BOARD OF WATER SUPPLY

Subject: Honolulu Board of Water Supply (BWS) Comments on the Red Hill Bulk Fuel Storage Facility (RHBFSF), Scope of Work for Destructive Testing Supplement – Destructive Testing Plan, Supplement to Administrative Order on Consent (AOC) and Statement of Work (SOW) Section 5.3.2, dated June 1, 2018 and Our Inspection on June 25, 2018 of Coupons Removed from Tank 14.

Figure 1: Coupon No. 7 viewed from the cut edge shows the corrosion and staining on the backside against the concrete. Remaining wall appears to be about 2 mm or 0.079-inches.

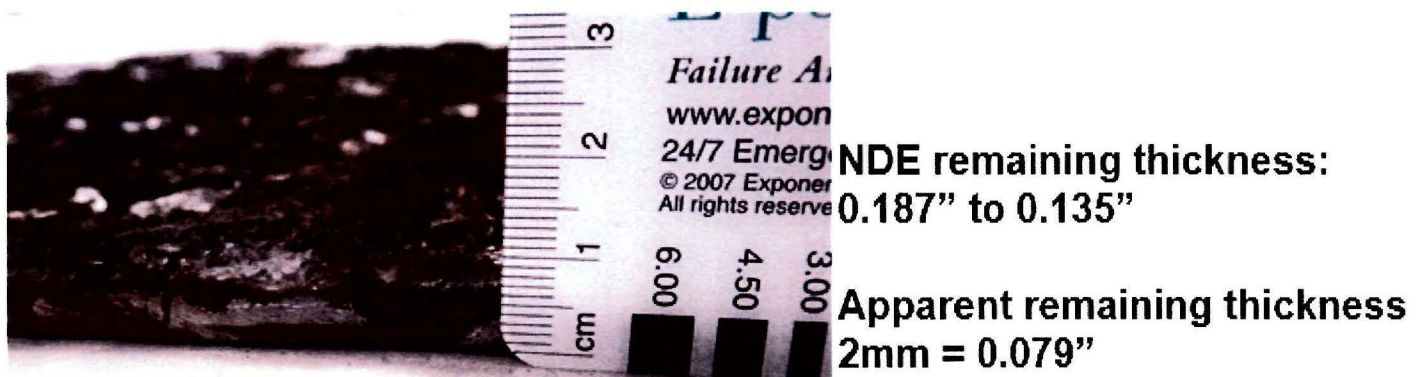
1. Presence of substantial backside corrosion — There were areas of substantial corrosion on the backside (non-fuel wetted side) of the ¼-inch thick steel plate lining the tank (Figure 1, for example).

Furthermore, our visual observations of some coupons suggest that the actual defect depth was greater than measured by either NDE technique. For example, Coupon #7 measurements indicated a remaining wall of either 0.157-inches or 0.135-inches whereas the cut edge of this coupon appears to show a minimum

remaining wall of 0.079-inches (see Figure 1). These are our observations, and we look forward to reviewing the results of the independent testing laboratory for confirmation.

Figure 2: Backside of Coupon No. 2 - The dark horizontal stain is likely corrosion product and/or hydrocarbon stains. Drip seen running down backside.

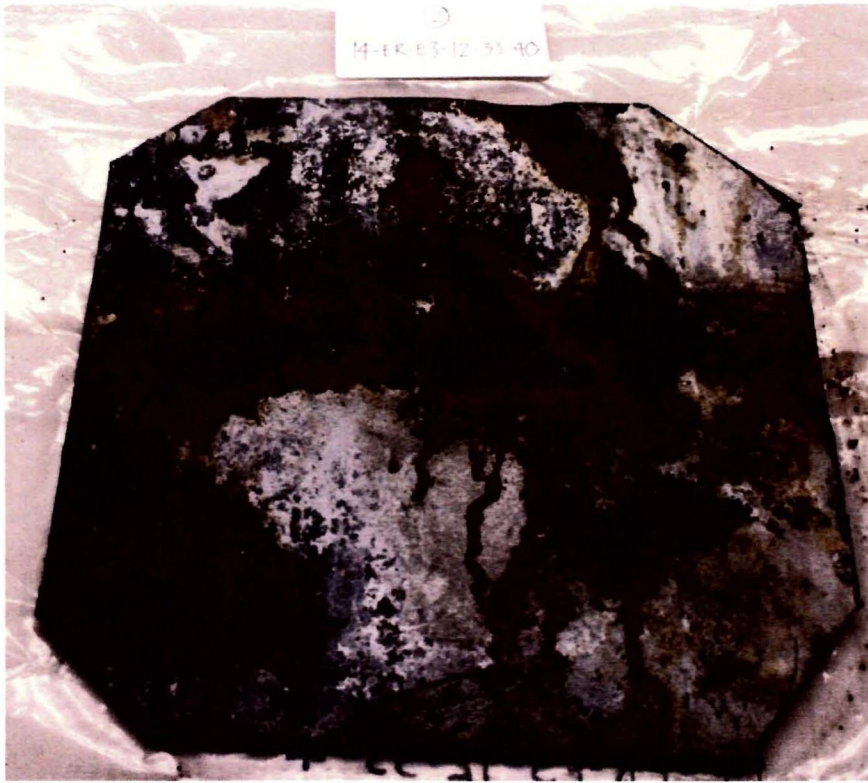
2. Staining on Backside of Steel — Deposits on the backside of some coupons suggest hydrocarbon-staining and should be tested for presence of released product (Figure 2, for example).
3. Non-Destructive Evaluation (NDE) Technique Underestimates Remaining Wall Thickness — Corrosion pit depths measured on the cut specimen edges suggest that NDE techniques were not able to locate and measure the thinnest wall of the coupon. For instance, the scale shown in Figure 1 indicates the wall along the edge of Coupon No. 2 has thinned to about 0.079-inches (reduced from 0.25-inches thick when new). However, the two NDE techniques (screening and Prove-up) predicted the thinnest area of this coupon to be 0.187-inches and 0.135-inches, respectively, underestimating the measured thickness by 51%.
